APPEAL SUMMARY

Appeal ID: 20255	Project Address: 2121 NE Broadway St		
Hearing Date: 4/17/19	Appellant Name: Paul Ries		
Case No.: B-008	Appellant Phone: 5038280028 x1		
Appeal Type: Building	Plans Examiner/Inspector: Steven Freeh		
Project Type: commercial	Stories: 1 Occupancy: F, M, B Construction Type: III-B		
Building/Business Name: Twisted Croissant	Fire Sprinklers: No		
Appeal Involves: Reconsideration of appeal	LUR or Permit Application No.: 18-236958-CO		
Plan Submitted Option: pdf [File 1] [File 2] [File 3]	Proposed use: Bakery for Croissants

Twisted Croissant Tenant Improvement

EXHIBIT "A"

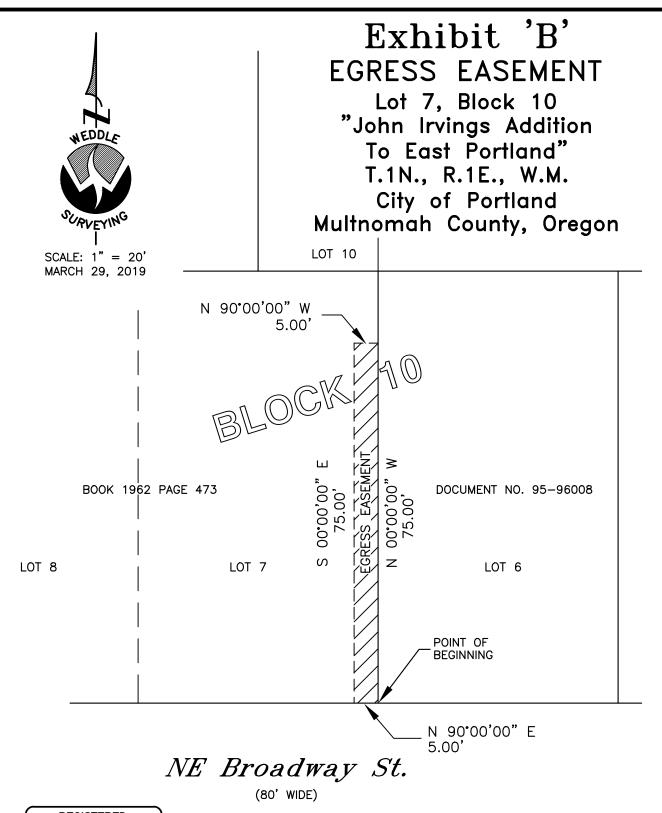
We propose a legal easement located between subject property and the adjoining property to the West. This easement will provide safe, direct, and unobstructed access to NE Broadway to the South. See attached survey and legal description.

Access to Public Way with egress across property line with egress access / maintence agreement: Granted provided the easement is a minimum of 5 feet wide and minimum 75 feet in length to the public way.

The easement must include language that establishes the edge of the easement on the adjacent lot as the implied property line for the purpose of determining fire separation distance for future development on the adjacent lot.

NEW FLOOR & LIFE SAFETY PLAN

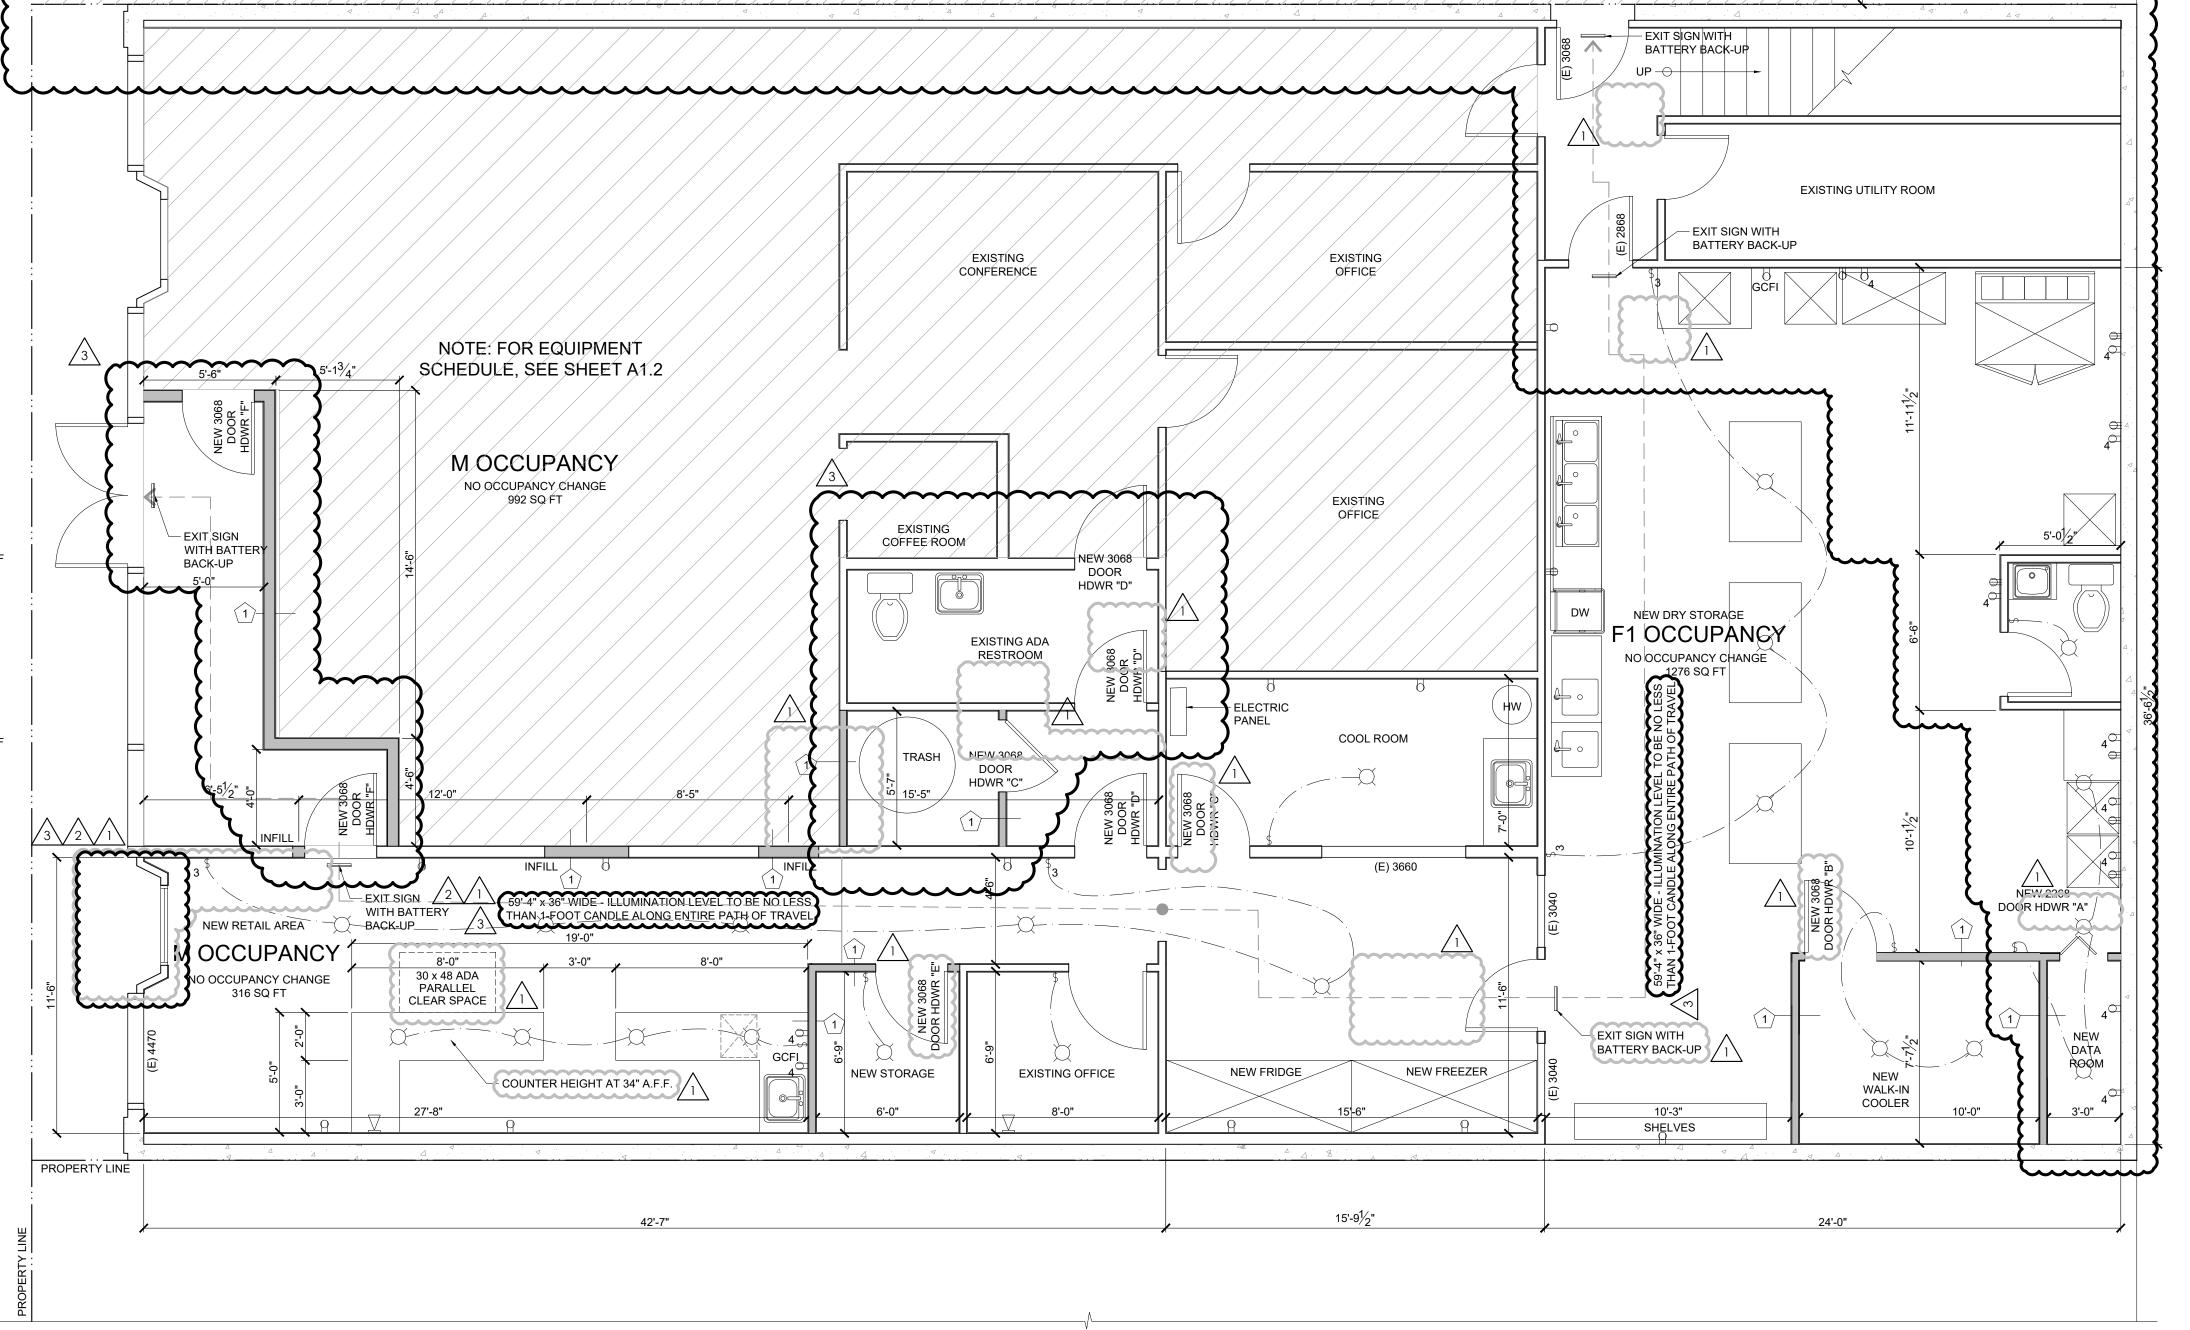
This easement is needed to provide direct access to a public way from the required second exit from the building. This building is existing, as is this rear door. Due to this rear door opening over the property line, an easement is needed so that this second exit is code compliant.

EXIT EGRESSÆASEMENT
